RE: Revised Application Materials
565 Kennedy Road, City Council #2024.SC16.1

Further to ongoing discussions between the owners of 565 Kennedy Road and Councillor Kandavel following the September 19, 2024 Scarborough Community Council meeting, please find attached the updated Architectural Plans reflecting a revised development scheme comprising a 10-storey mixed use building with 2 levels of underground parking.

PROPOSED MIXED USE DEVELOPMENT

565 Kennedy Rd, Scarborough, ON M1K 2B2

A3.00

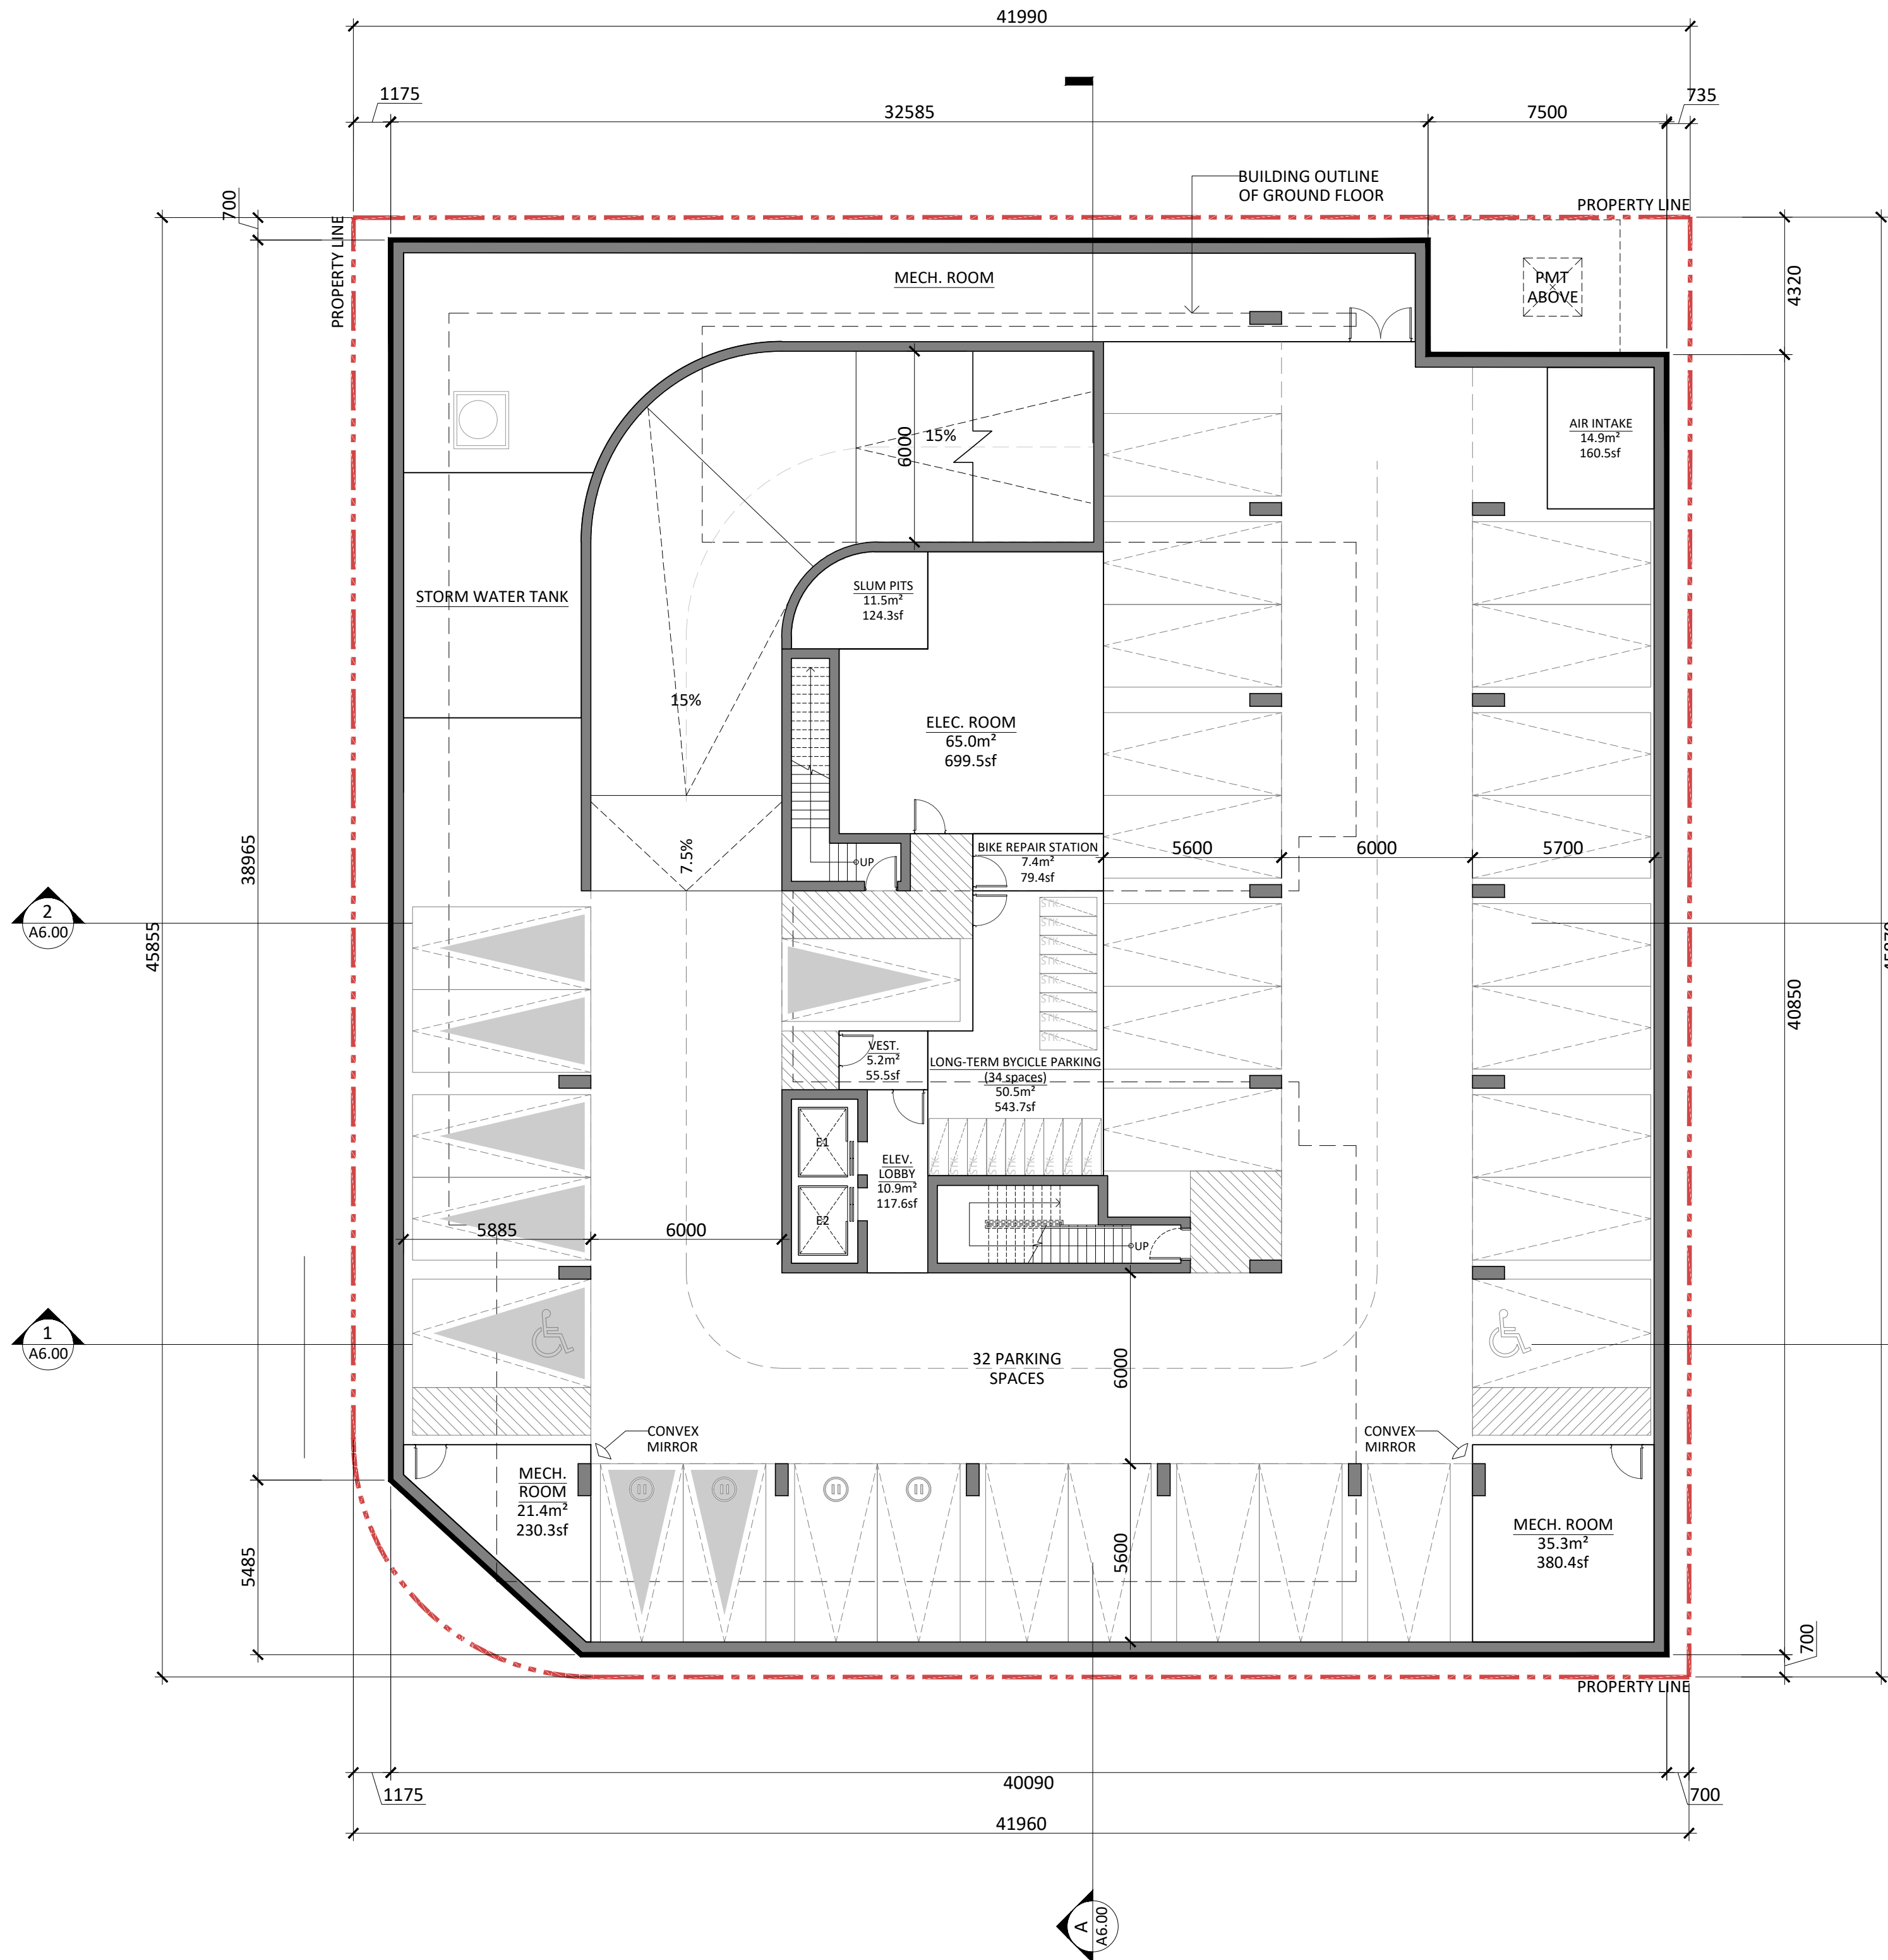
- Increasing the number of underground parking levels from one (1) to two (2), adding up to an additional 32 additional parking spaces;
- Increasing the building height from 9-storeys (28.8m) to of 10 storeys (31.8 metres);
- Increasing the number of residential units from 113 to 127;
- Reducing the amount of outdoor amenity space from 2.0 sqm per unit to 1.77 sqm per unit; and,
- Increasing Residential Gross Floor Area from 7,055.8 sqm to 7,860.0 sqm.
